# Access Compliance Report

## Public Rights-of-Way

### (Curb Ramps)

Intersection ID: 49390	Main Street: DISTRICT_DR	Cross Street: SHORTHORN_ST	Location: NE
ADA ID: 012C9ABB5339	Ramp Type: Perp	Initial Pass/Fail: Fail	Overall Compliance: No
		Severity Score: 10

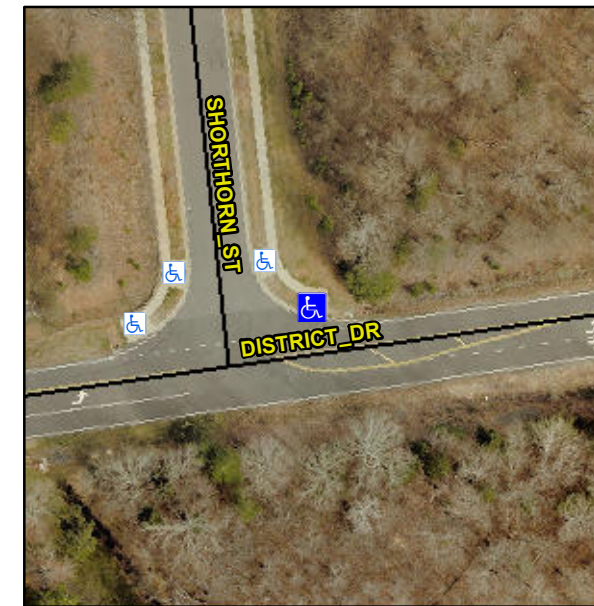
**Not Found, R304.5.1**

Compliance	Description	Data	Compliance	Description	Data
N/A	Ramp Length (in)	97.0	Yes	Ramp Slope (%)	6.1
No	Ramp Width (in)	47.0	Yes	Ramp XSlope (%)	3.1
N/A	Flare Type LT	N/A	N/A	Flare Type RT	N/A
N/A	Flare Slope LT (%)	N/A	N/A	Flare Slope RT (%)	N/A
N/A	Flare Traversable LT?	N/A	N/A	Flare Traversable RT?	N/A
N/A	Landing Length (in)	N/A	N/A	DWS Provided?	N/A
N/A	Landing Width (in)	N/A	N/A	DWS Contrast?	N/A
N/A	Landing Slope (%)	N/A	N/A	DWS Length (in)	N/A
N/A	Landing X Slope (%)	N/A	N/A	DWS Full Width?	N/A
N/A	Landing Curb? (Y/N)	N/A	N/A	DWS Offset (in)	N/A
N/A	Shared Landing?	N/A			
N/A	Gutter Ponding?	N/A	N/A	Gutter Slope (%)	N/A
N/A	Gutter Lip Ht (in)	0.5	N/A	Gutter X Slope (%)	N/A
N/A	Painted X Walk1?	No	N/A	Painted X Walk2?	N/A
	X Walk 1 Direction	To S		X Walk 2 Direction	N/A
N/A	X Walk 1 Width (in)	N/A	N/A	X Walk 2 Width (in)	N/A
	X Walk 1 Slope (%)	3.6		X Walk 2 Slope (%)	N/A
	X Walk 1 X Slope (%)	8.1		X Walk 2 X Slope (%)	N/A

**Remove & Replace Entire Ramp.**
